**Subject:** Submittal of Replacement Pages to Update the NAC-UMS<sup>®</sup> FSAR from Revision 4 to Revision 5 (Docket No. 72-1015)

**10 CFR 72.48 Evaluation Summary Report**

**NAC-UMS<sup>®</sup> Universal Storage System  
(Docket No. 72-1015)**

<b>NAC INTERNATIONAL</b>		
REINFORCING BAR AND CONCRETE PLACEMENT, VERTICAL CONCRETE CASK (VCC) NAC-UMS®		
PROJECT	790	DRAWING
		562
		REV
		16
		1-16-2008

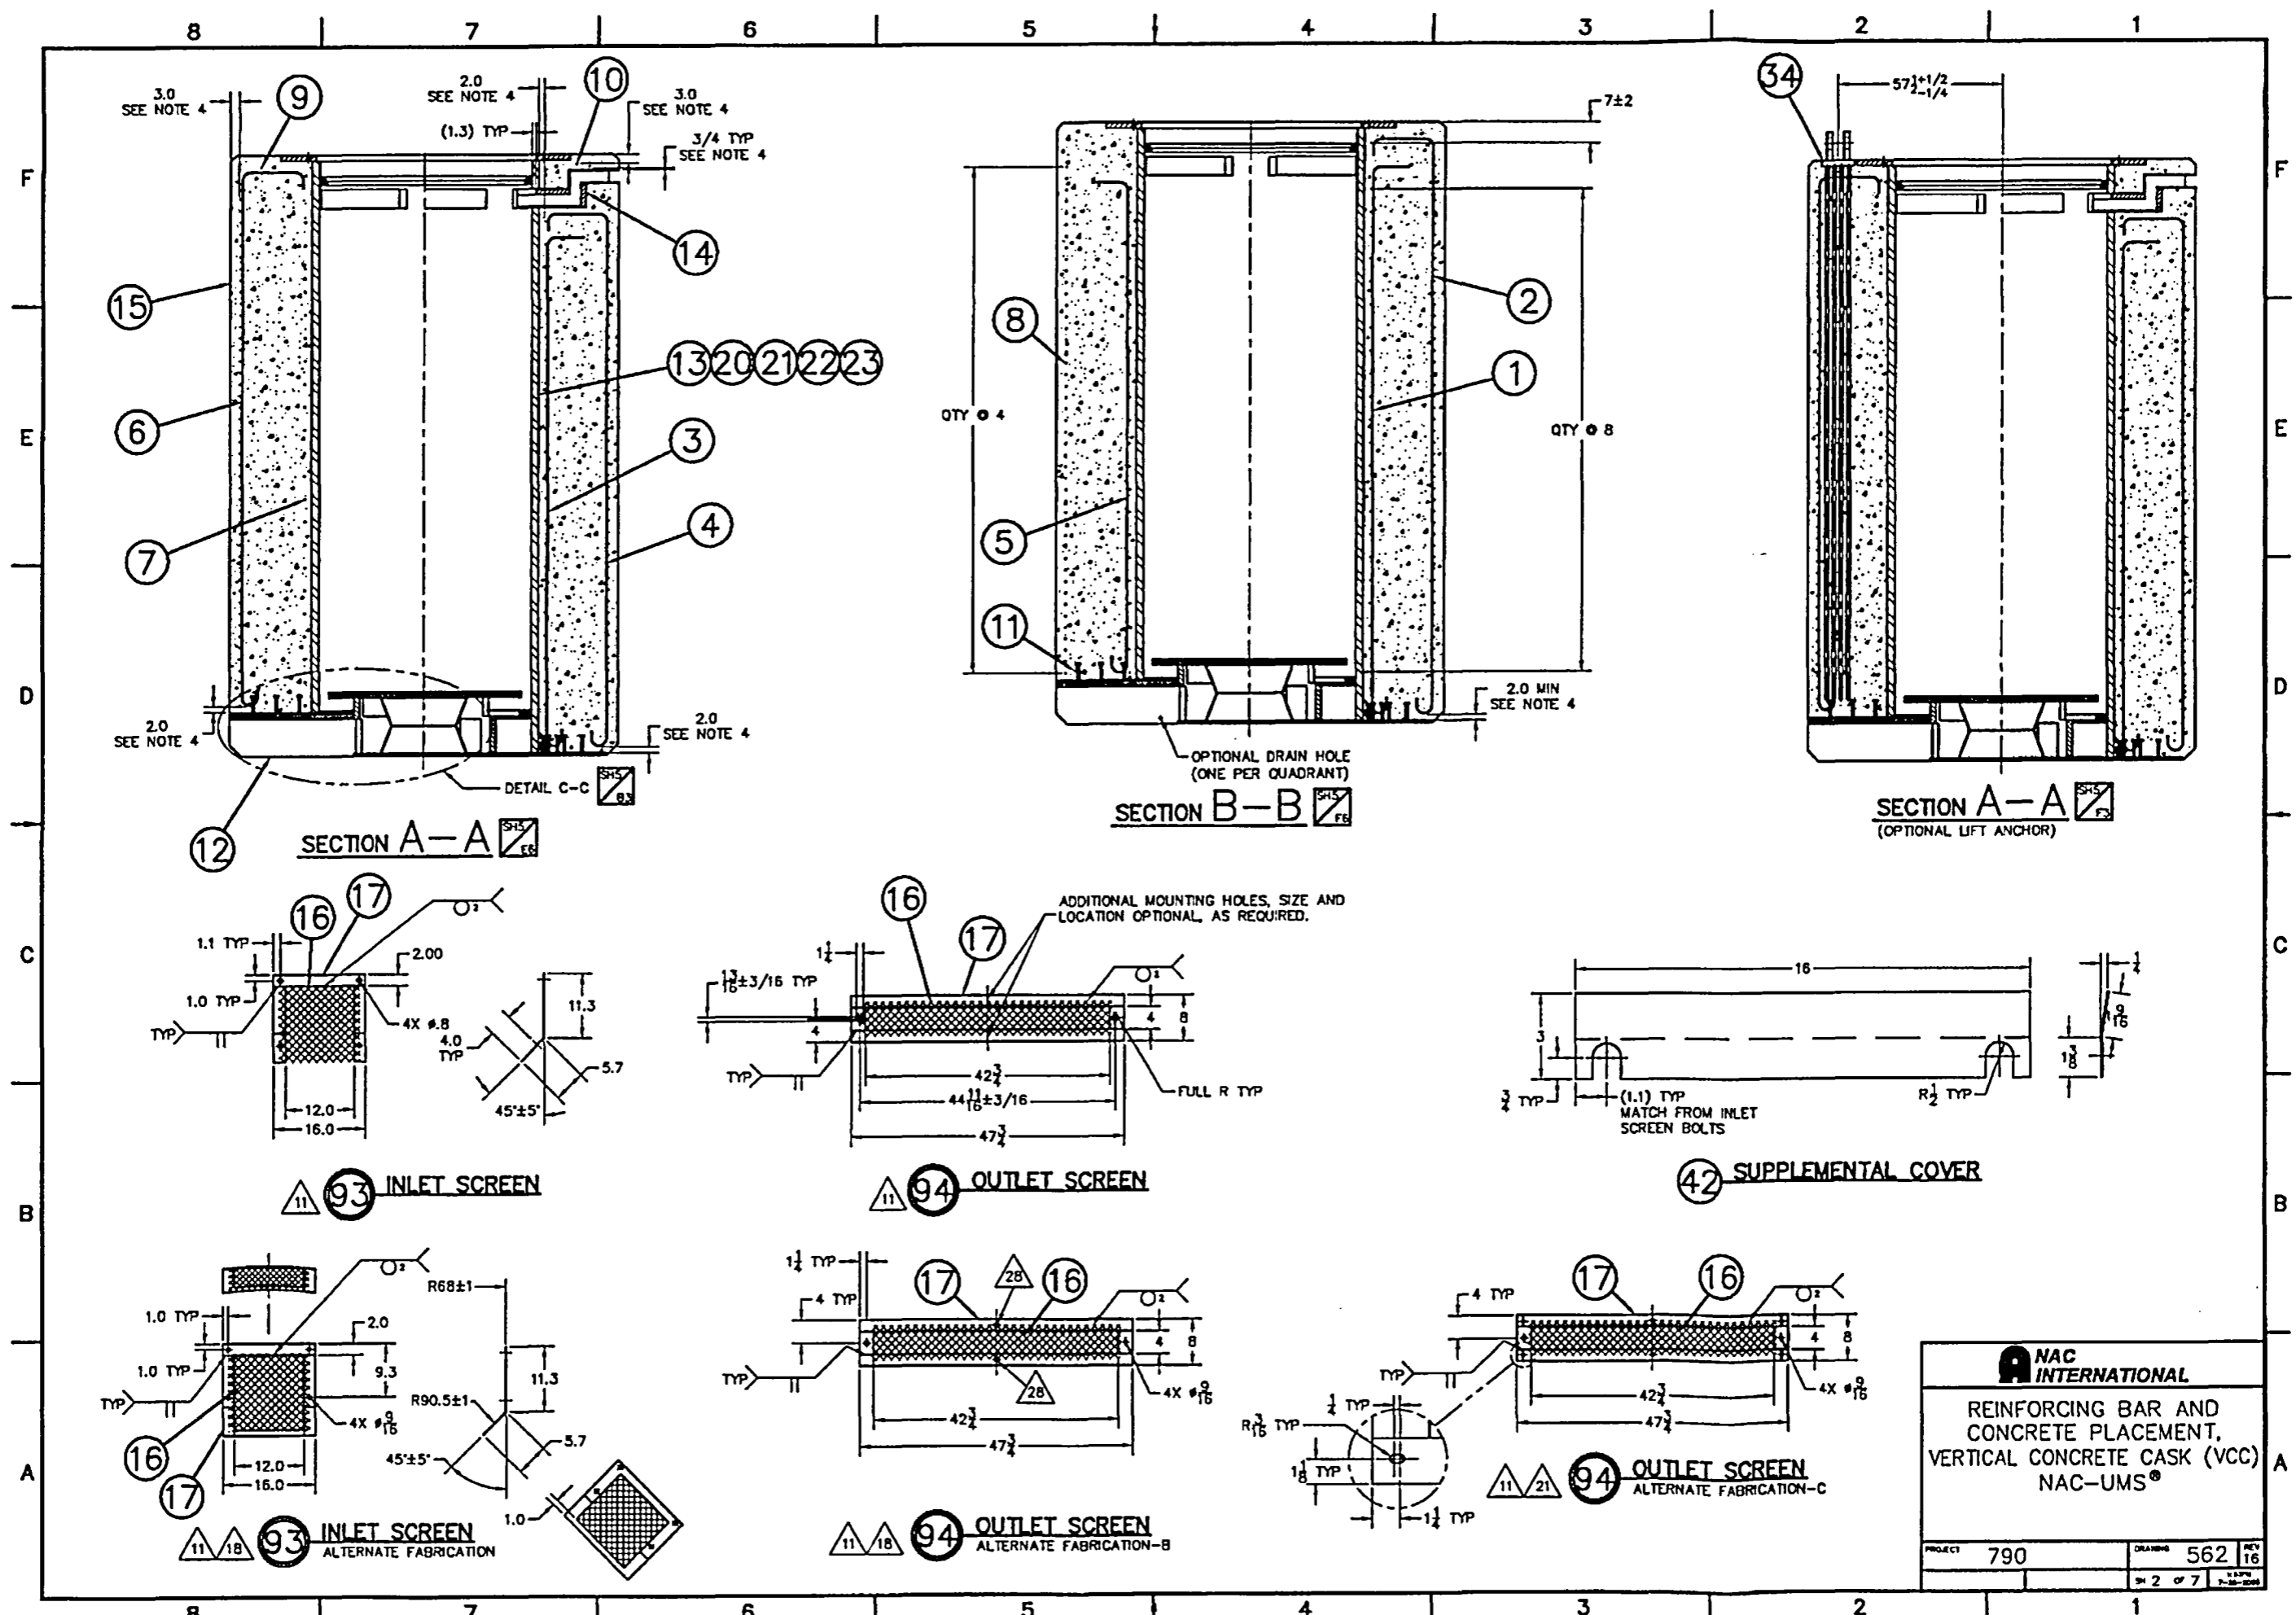
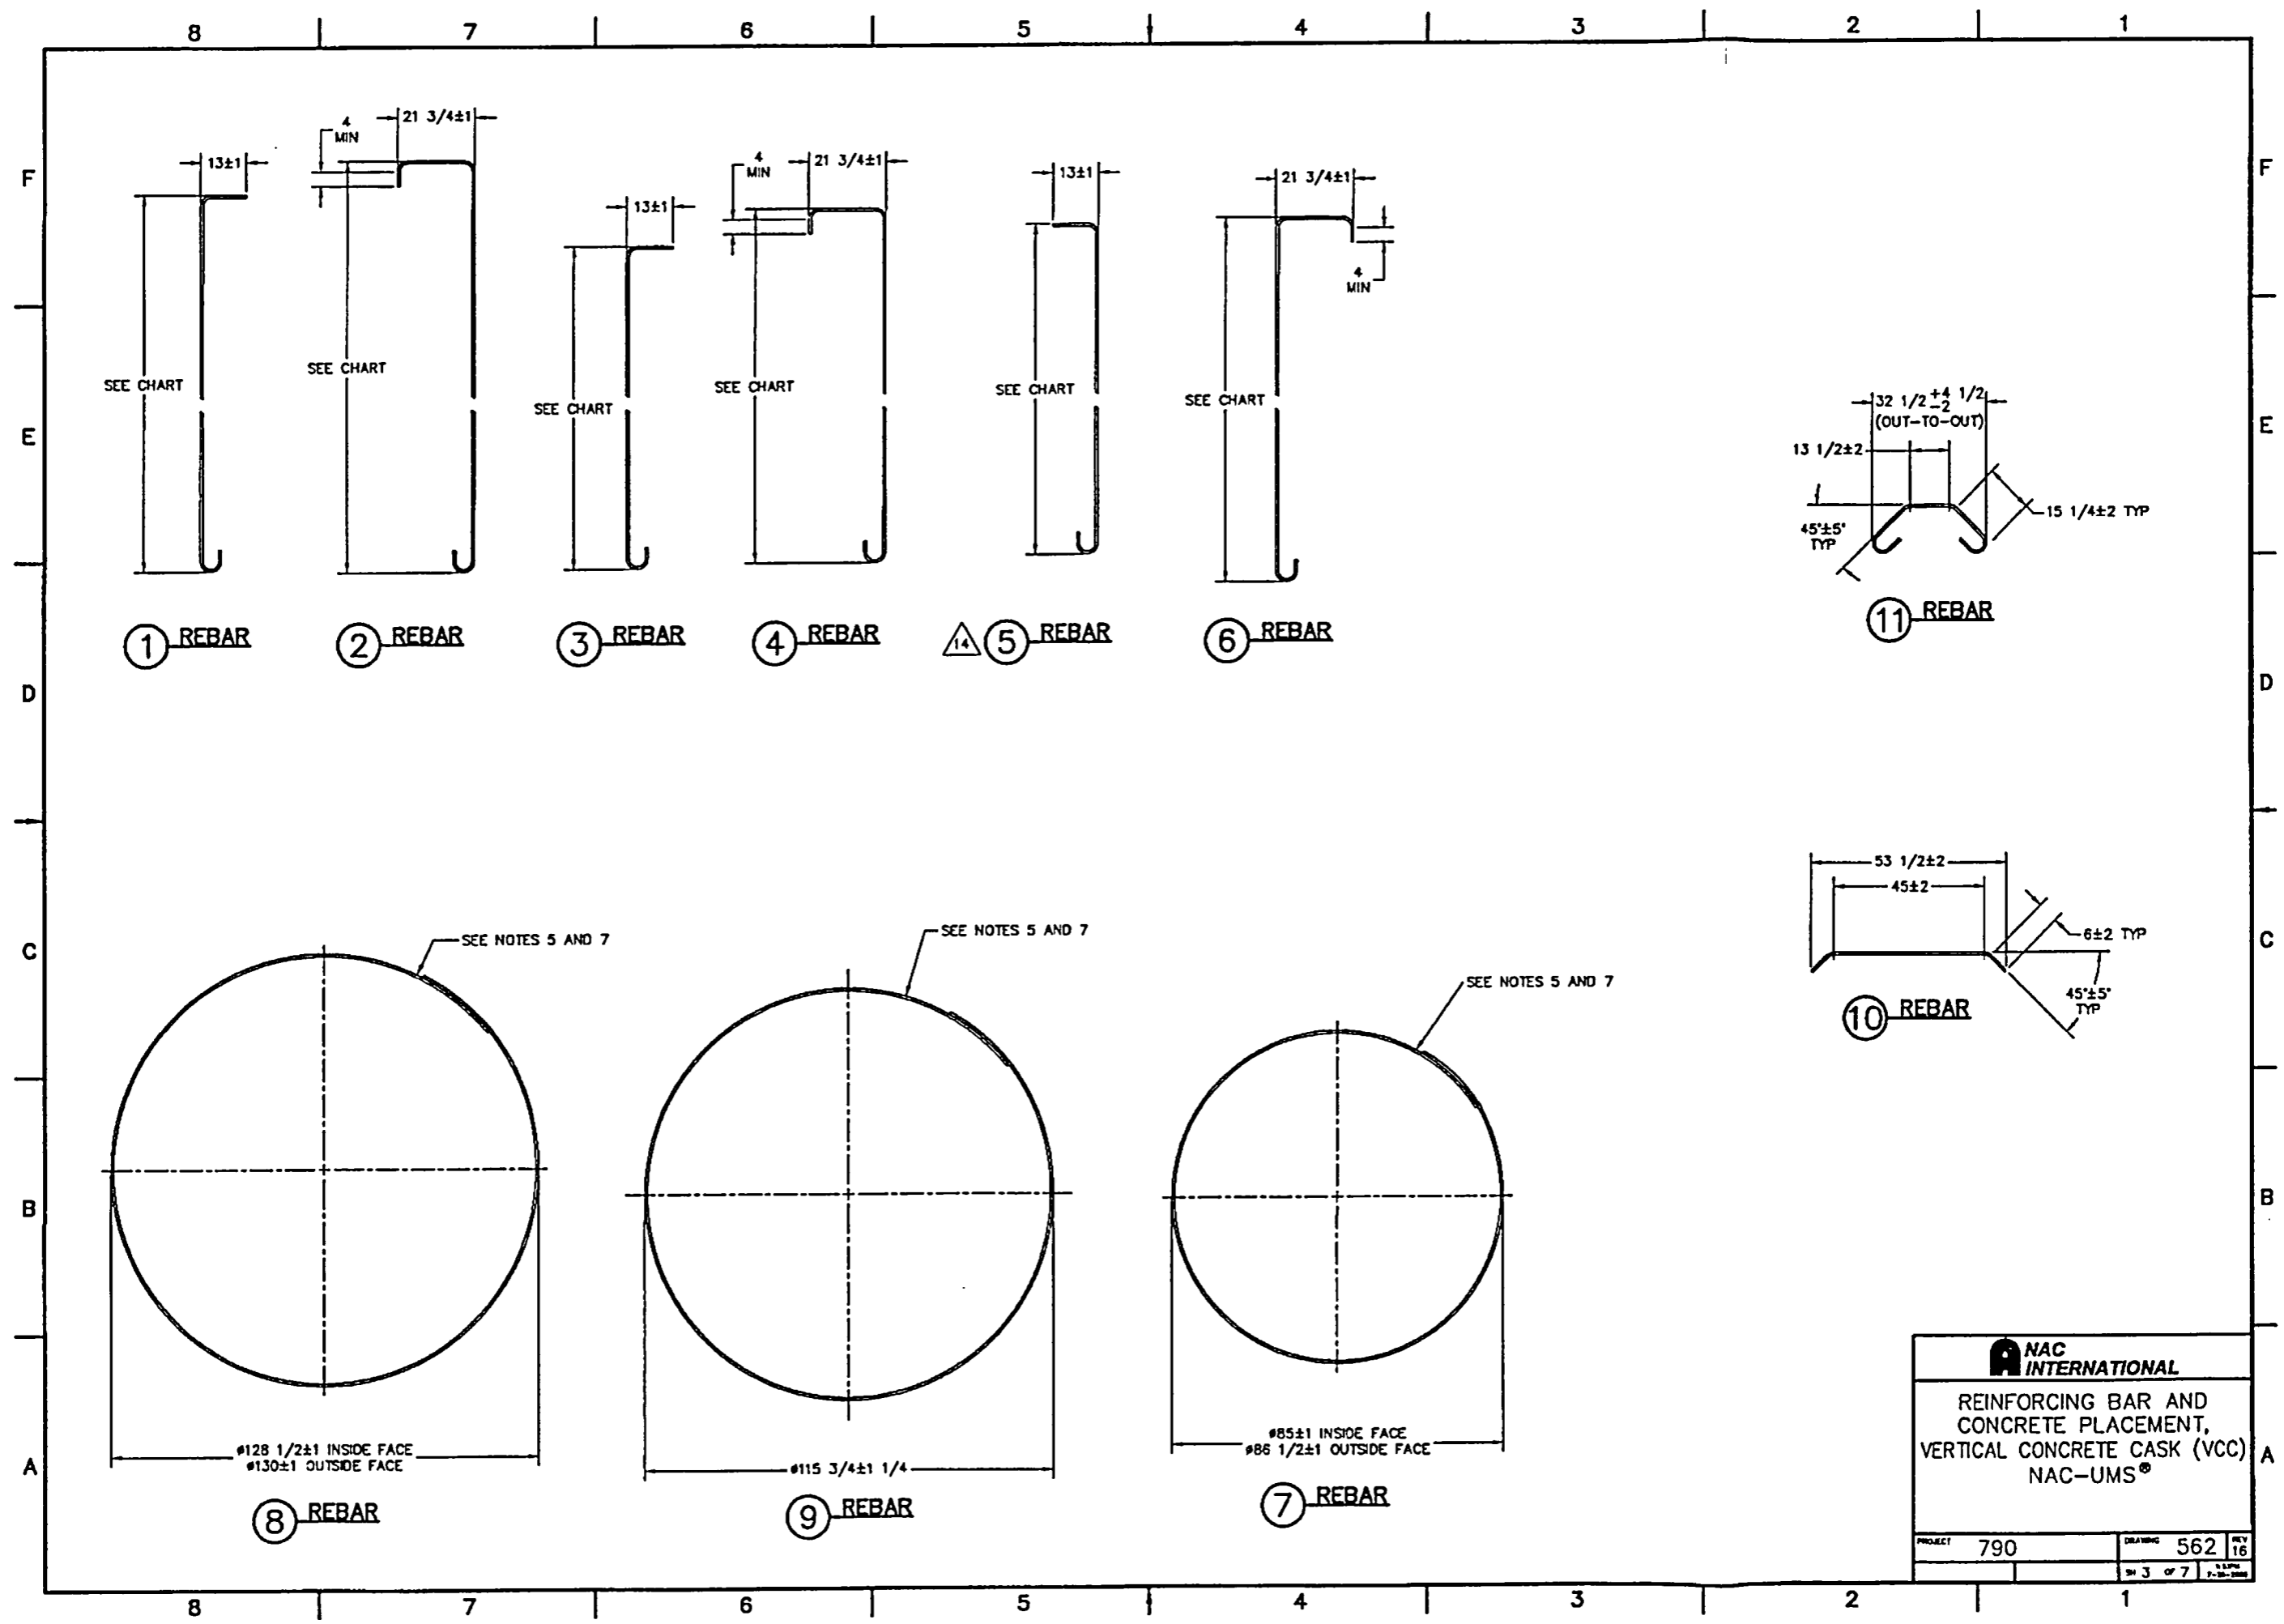
Revision 15 of Drawing 790-562 adds an “Optional Drain Hole (one per quadrant)” to the side of the inlet opening, in Section B-B.

Revision 16 of Drawing 790-562 changes Item 48, Retainer Plate, Alternate Fabrication-A (Sht 7 of 7, Zone D-6).

This drain hole will provide a path for water drainage in the cavity formed by the vertical concrete cask bottom plate, inlet sides, shell liner, stand, and the shield ring. The addition of this feature (a drain hole in the side of the air inlet) is insignificant as related to the structural and shielding calculations and will not affect the form, fit or function of the Base Weldment and/or other vertical concrete cask components.

This change will allow the concrete anchor and anchor mounting hole to be moved away from the edge of the concrete (near the side of the inlet tunnel). If the mounting hole is too close the edge of the concrete, the thin wall section of concrete between the mounting hole and inlet weldment crumbles. This results in the need to glue the anchor in place with an adhesive product and repair the crumbled concrete.
